29th November 2024
Our Ref: D2309
Planning Ref: DC/24/0552

RE: EBSWORTH COTTAGE, THE STREET, NUTBOURNE, WEST SUSSEX

With reference to the additional drainage comments dated 26th November 2024, please accept this as our response as the applicant's appointed drainage consultant.

SOUTHERN WATER

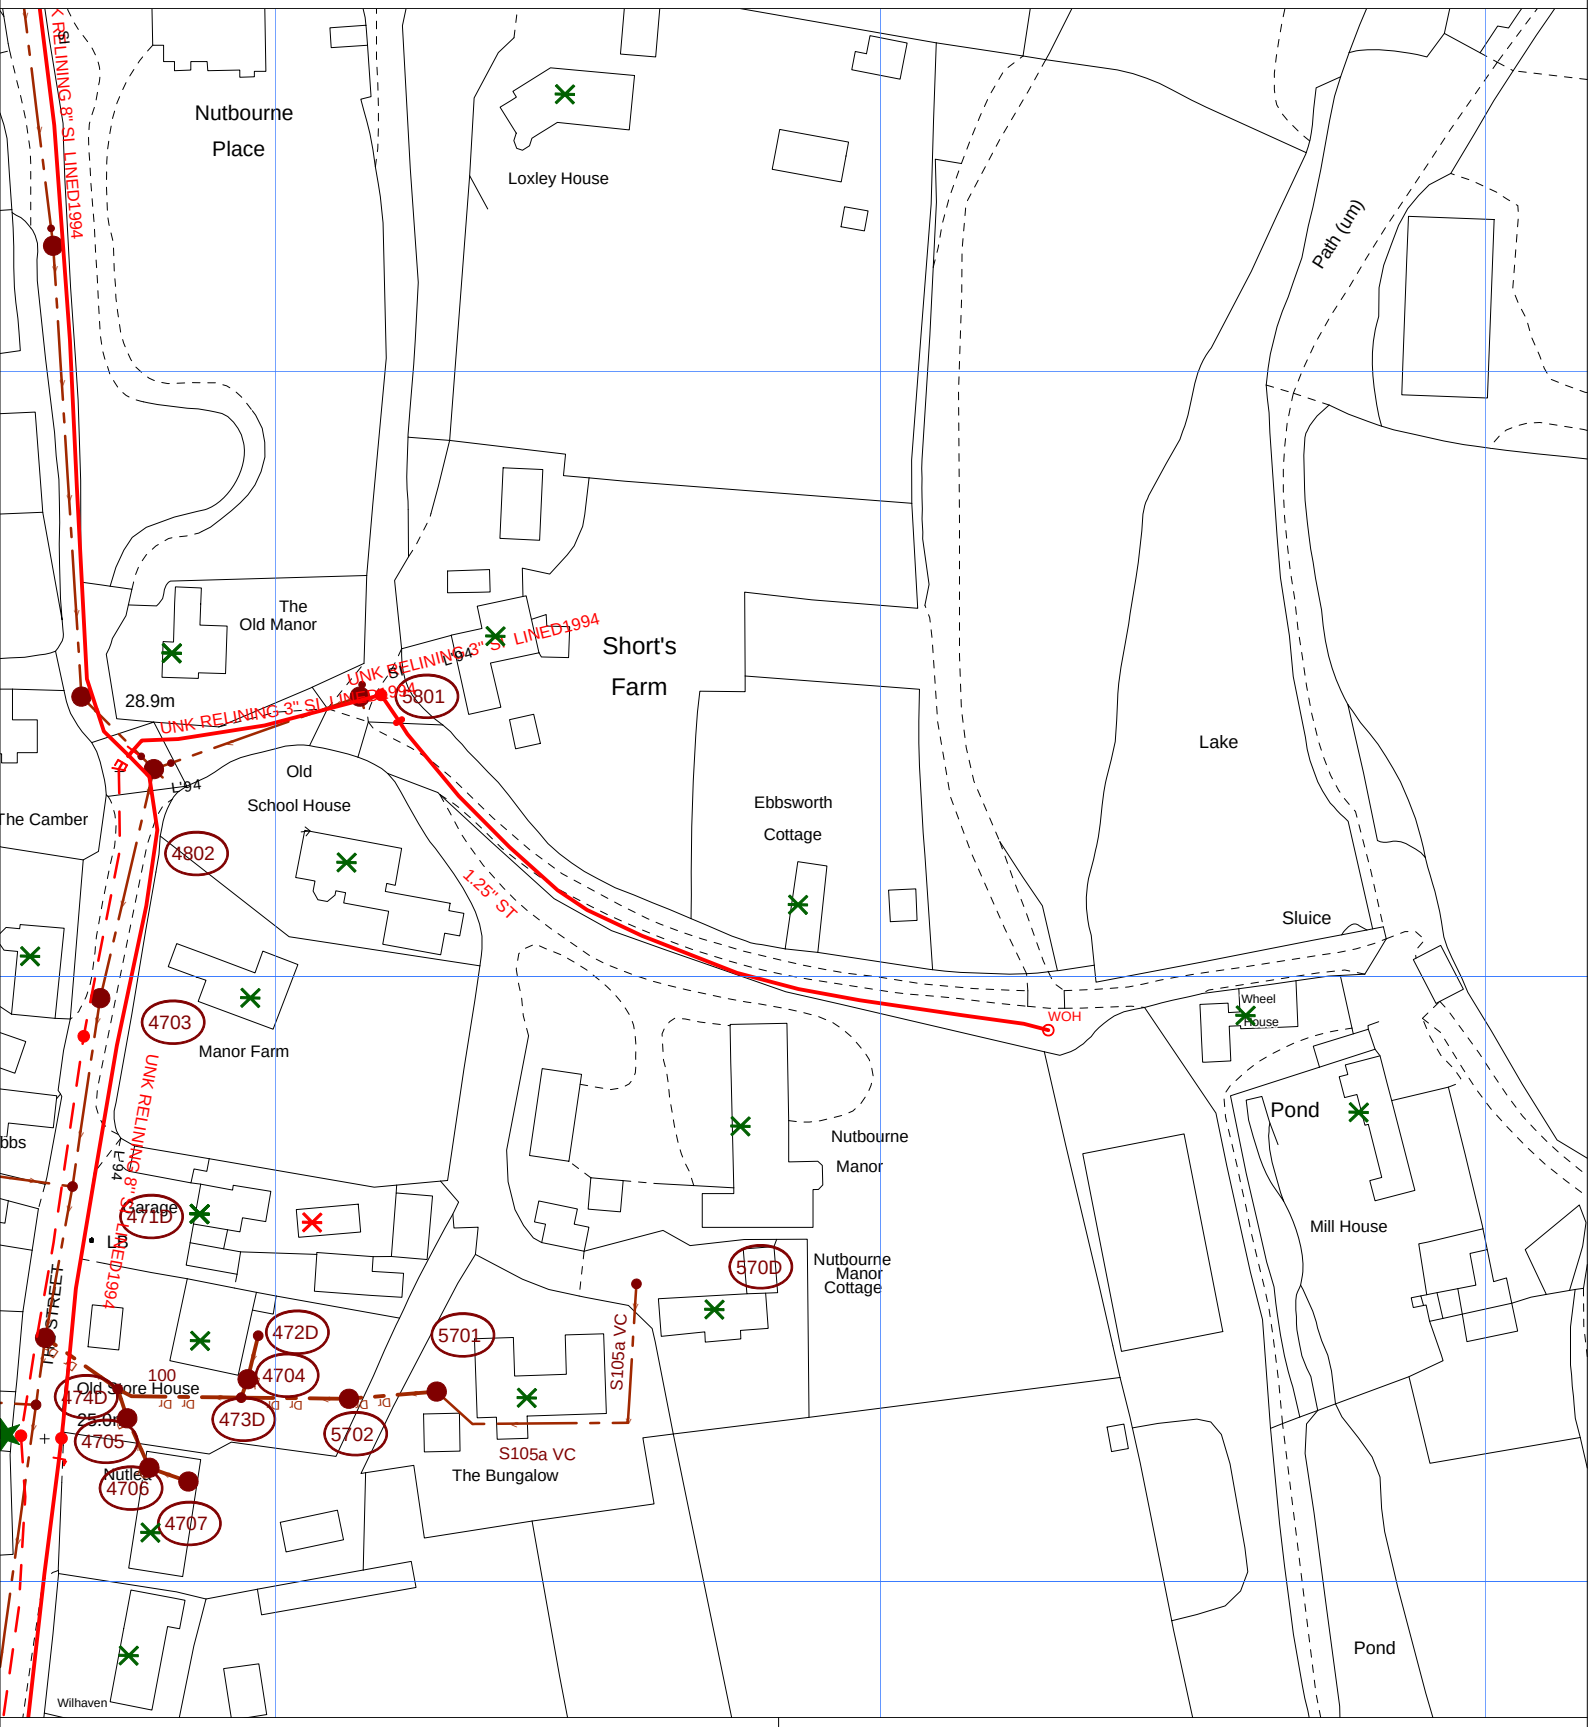
Enclosed are Southern Water's public sewer records for reference. The nearest foul water sewer is c. 70m north-west of the site. It is not considered appropriate to connect to this. The comment made in respect of *'If the connection point distance is more than the number of properties to be built on the site multiplied by 30m, a public sewer connection is considered unreasonable'* is also not considered relevant as the planning application does not propose the construction of any properties.
